PERMIT - Repair

P 531901

ON-SITE SEWAGE DISPOSAL SYSTEM HOWARD COUNTY HEALTH DEPARTMENT BUREAU OF ENVIRONMENTAL HEALTH

ADDRESS: 4651 Manor Ln. PROPERTY OWNER: Bill Flanigan

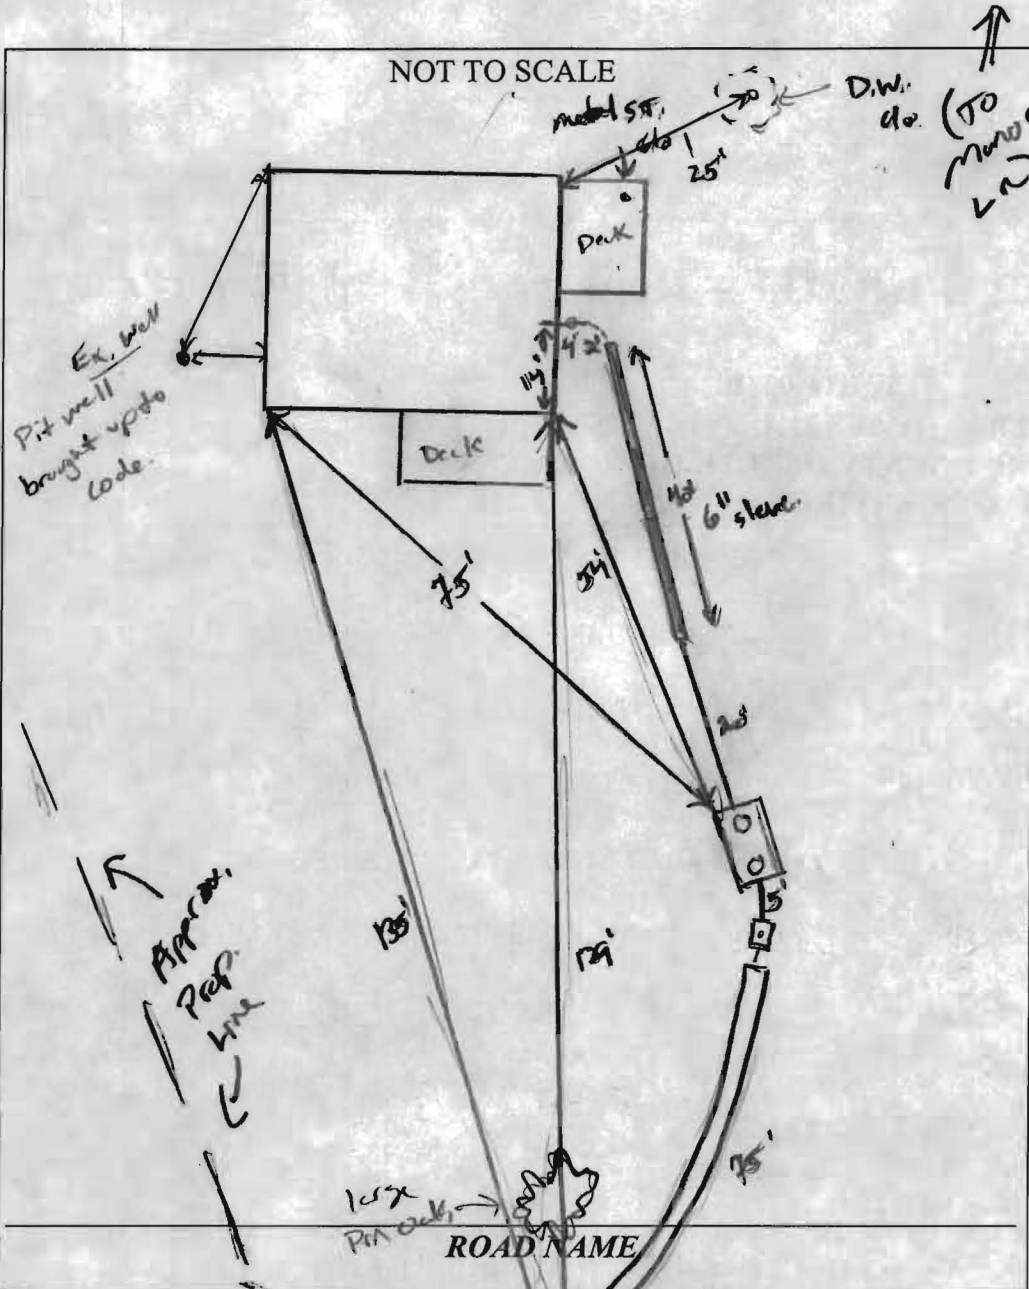
9/1/09 Keep new tank out at 100' well radius. Graded shot in field should be able to maintain 3' inlet into trench. Install 12" trench on contour. Call for trap (K)

INSTALLATION: 9/8/09 Contractor had 4" SMC installed up to tank location. 6" sleeve ~40' near house

9/9/09 System installed per installation spec's. Homeowner is to hook up plumbing inside house. Need confirmation that old metal tank and D.W. is pumped & collapsed. Ex. pit well needs to be grouted up for floor (K) 9/23/09 Well and old septic taken care of & verified via phone conversation w/ contractor (K)
